ANN ARBOR HISTORIC DISTRICT COMMISSION

Staff Report

ADDRESS: 220 S Seventh Street, Application Number HDC22-038

DISTRICT: Old West Side Historic District

WEST - GARAGE

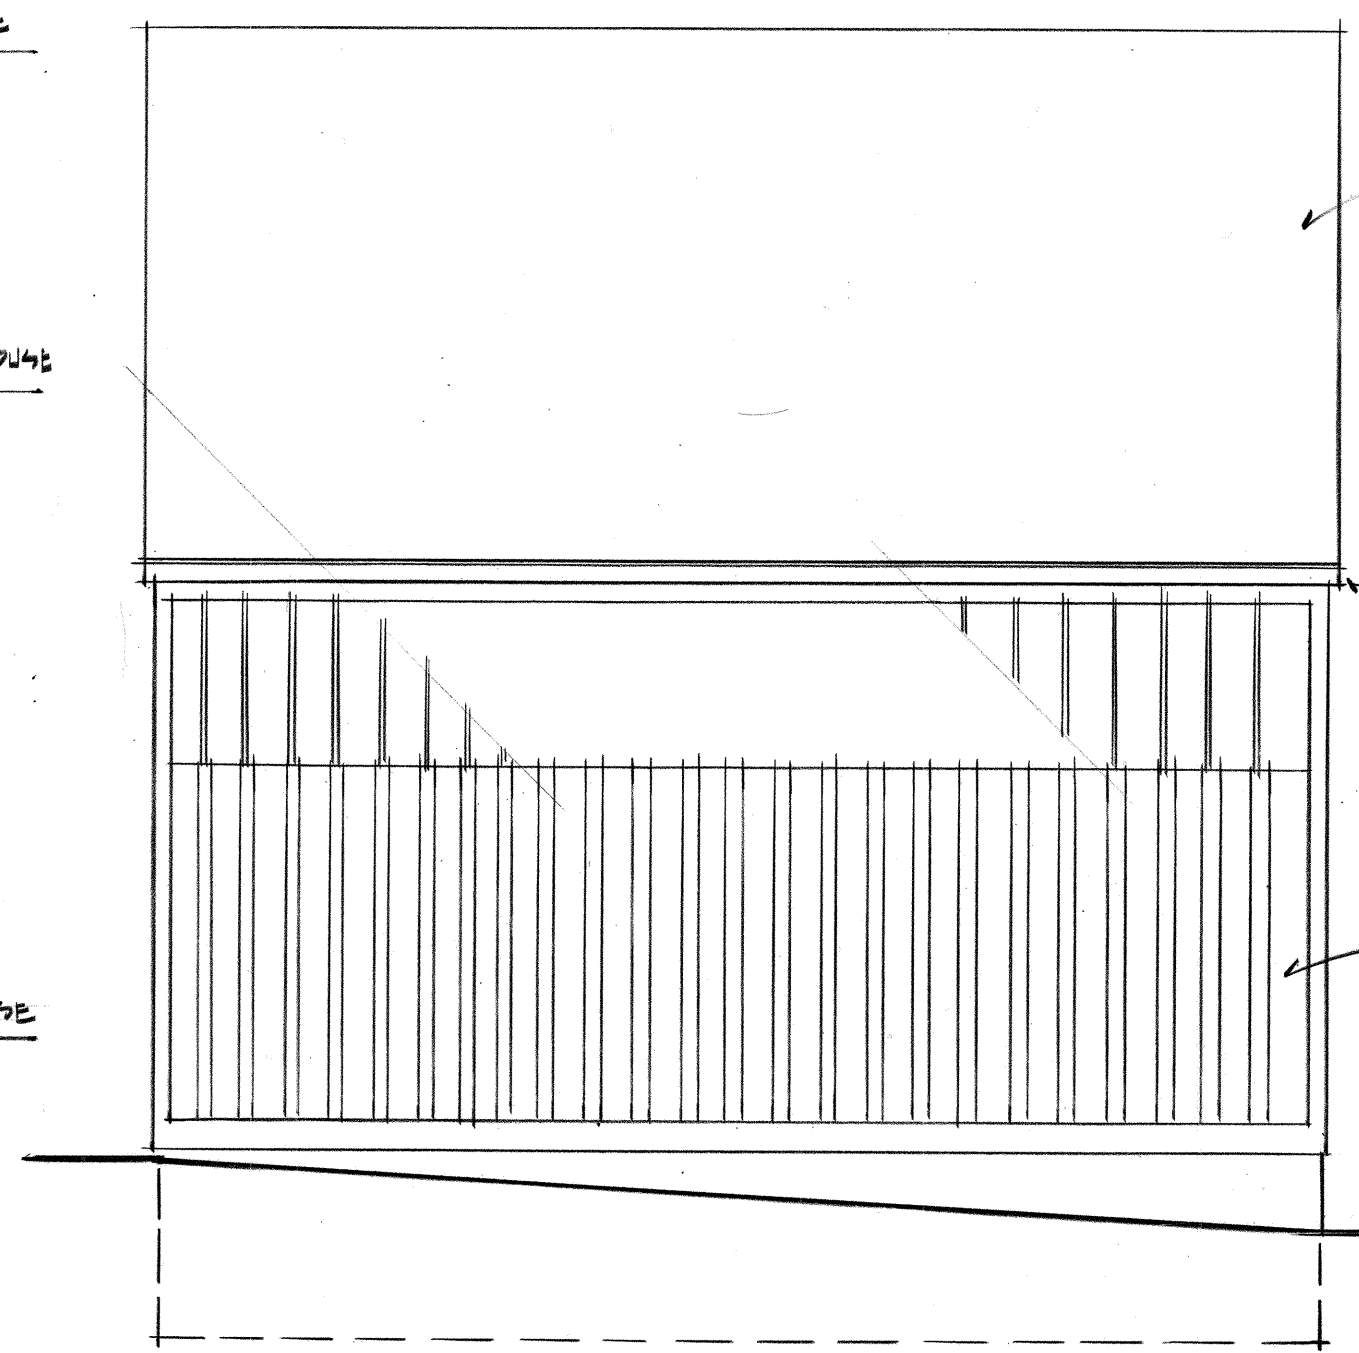
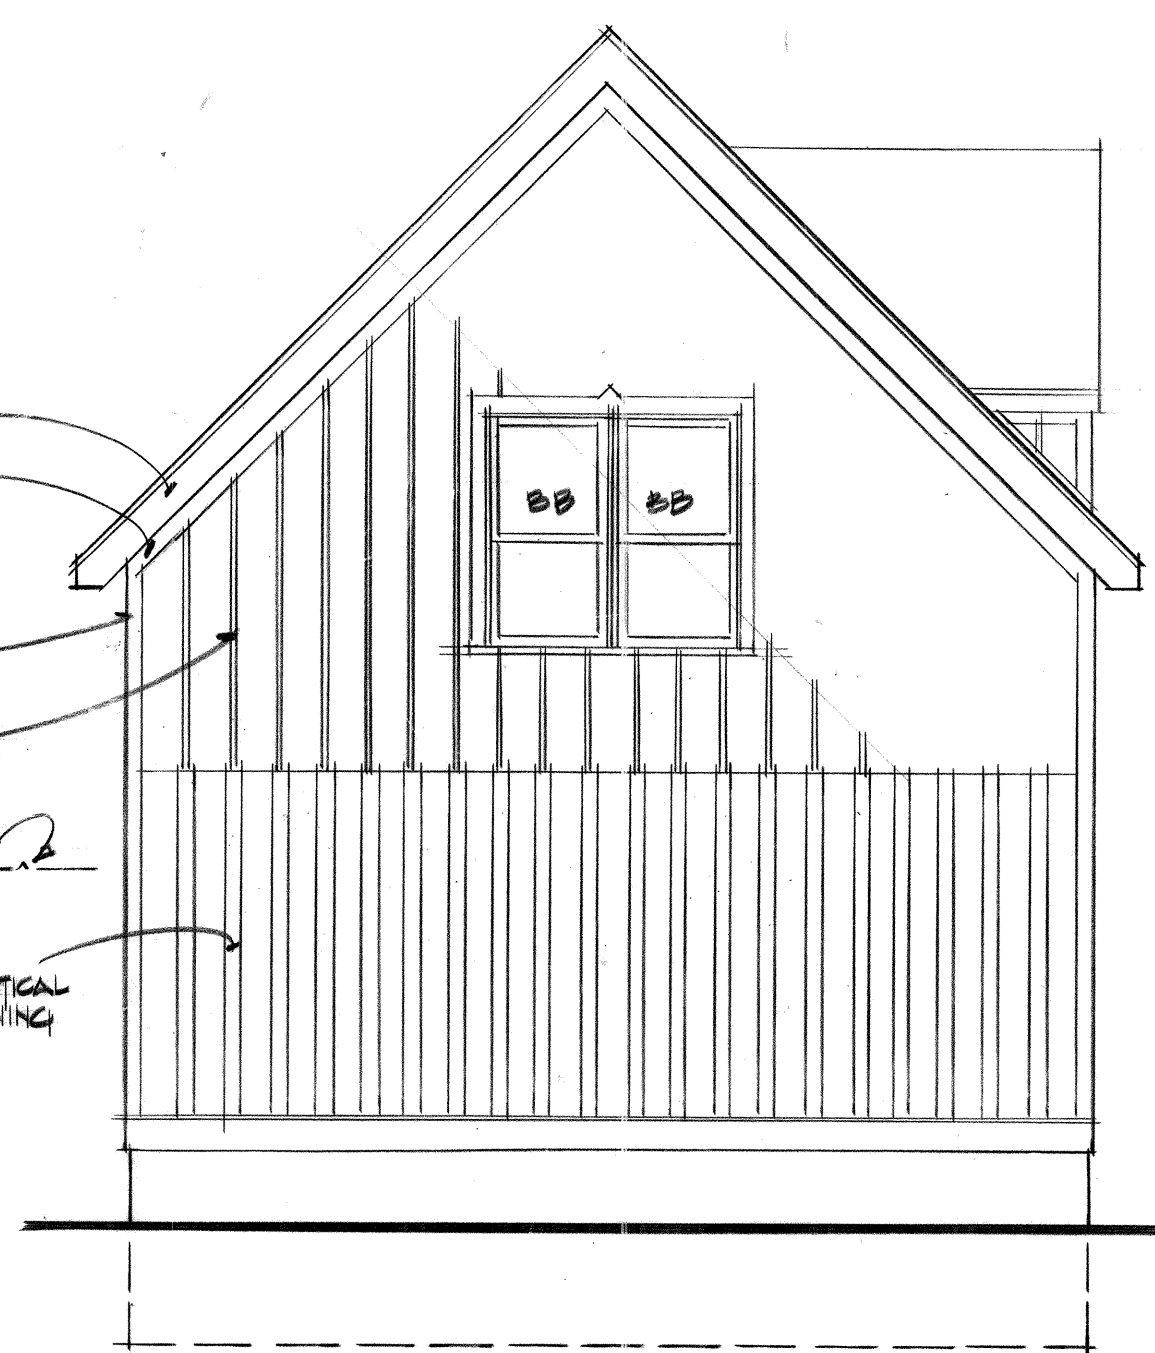
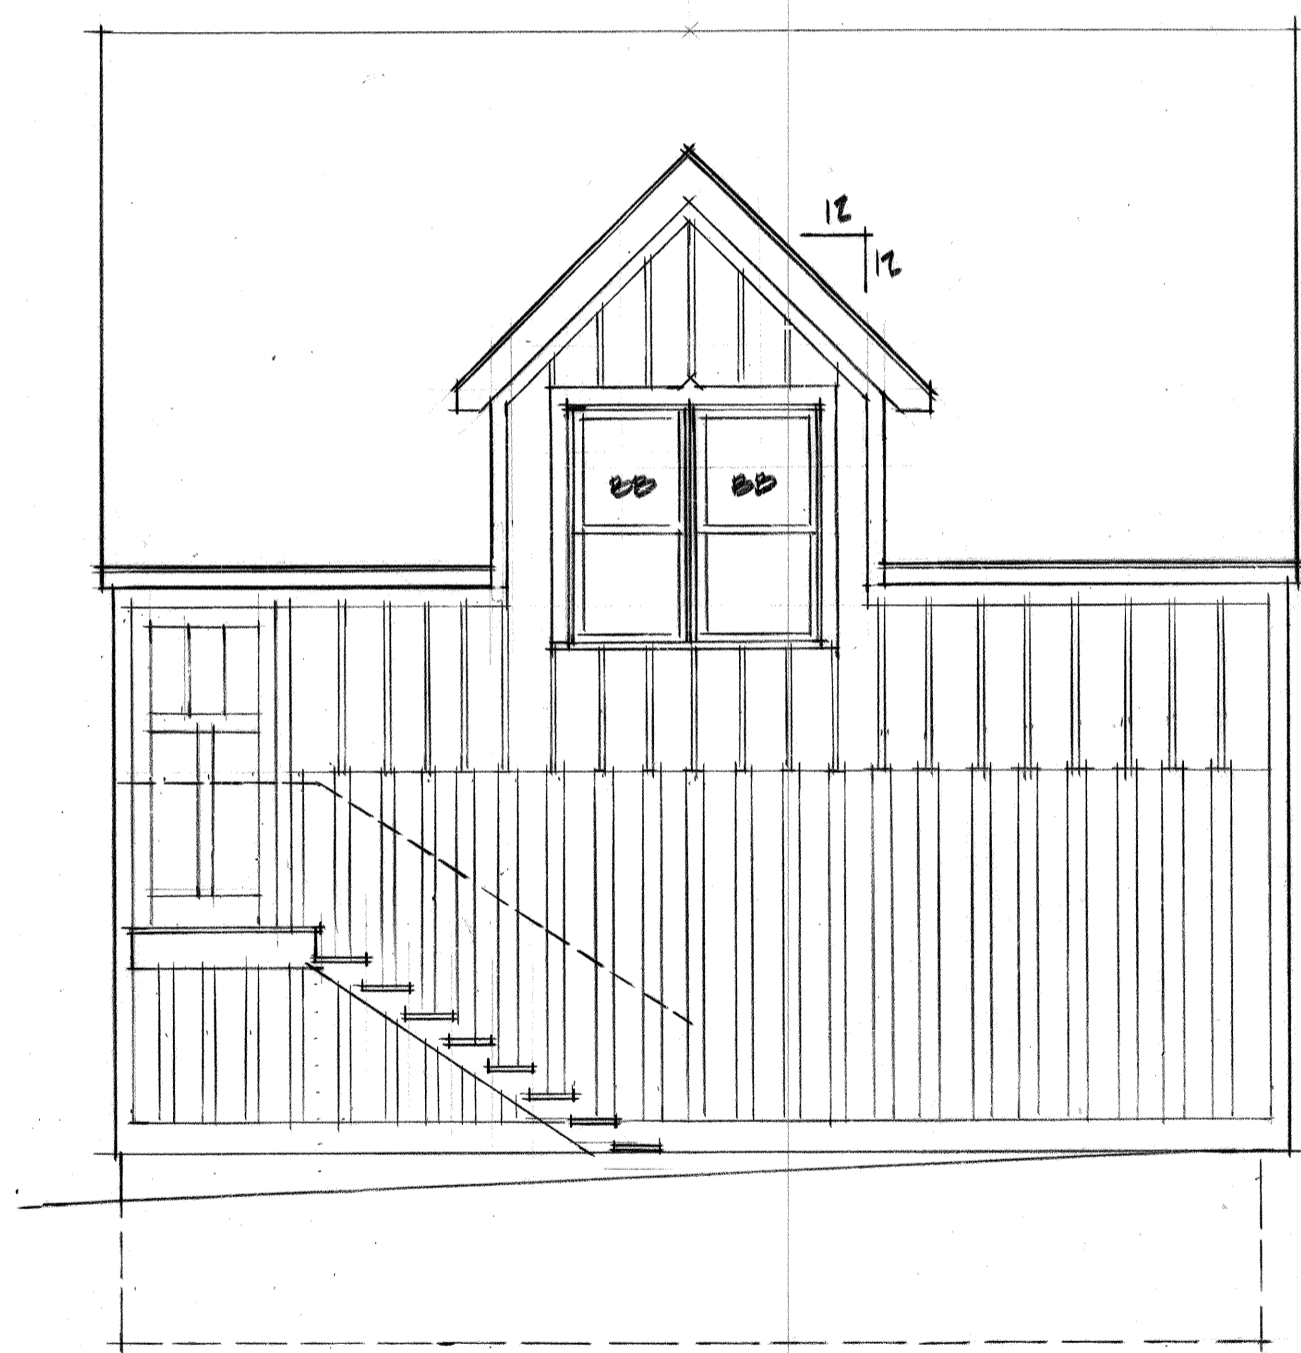
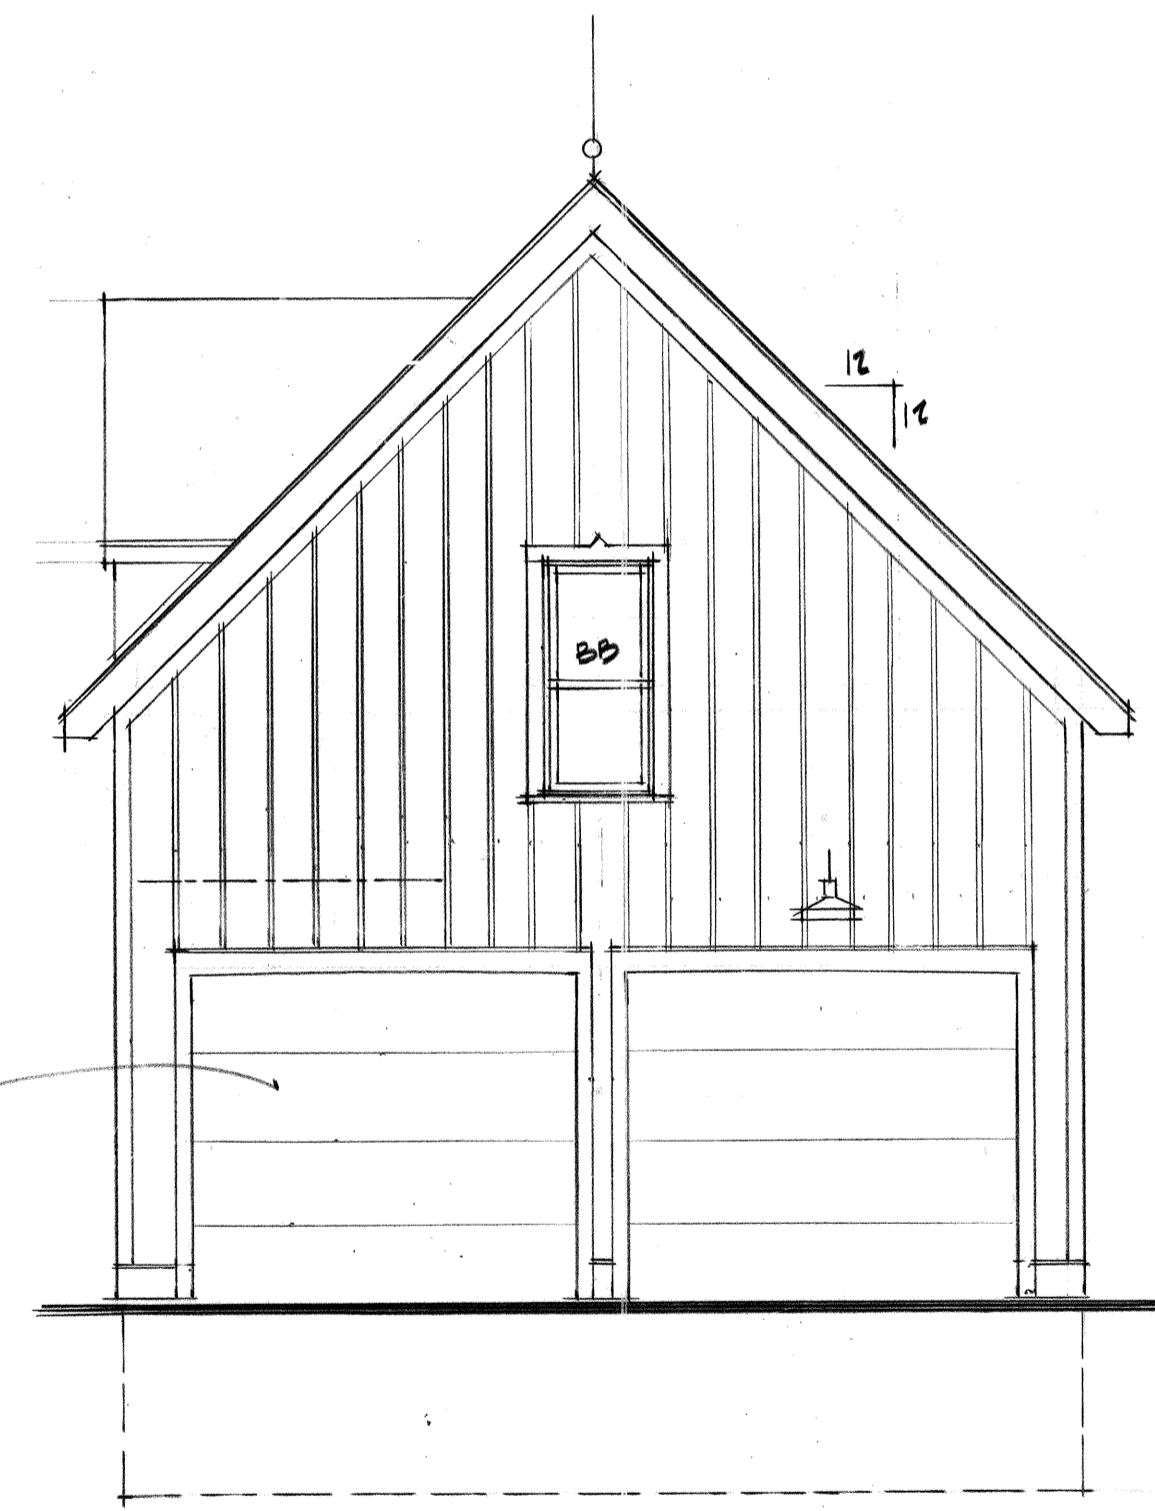
6. The garage to be removed is from the 1960s. A new, taller garage would be rebuilt in the same footprint in order to create second floor finished space. The garage features a wall dormer on the south roof plane to provide headroom for the stairs, which are on the exterior for a half-story then move to the interior. Cladding on three sides of the first floor is 1"x 8" vertical board with 3 3/4" openings in between to allow stormwater to move through the structure. The upper floor is solid 1"x12" board with 1"x3" battens, as is the front elevation, which also has roll-up break-away flood doors.

I move that the Commission approve with conditions and issue a certificate of appropriateness for the application at 220 South Seventh Street, a contributing property in the Old West Side Historic District, to replace a modern garage with a taller garage in the same footprint, on the condition that the door details are reviewed by staff in a separate application. As conditioned, the work is compatible in exterior design, arrangement, materials, and relationship to the building and the surrounding area and meets *The City of Ann Arbor Historic District Design Guidelines* for additions, and *The Secretary of the Interior's Standards for Rehabilitation and Guidelines for Rehabilitating Historic Buildings*, in particular standards 1, 2, 9 and 10, and the guidelines for additions and building site.
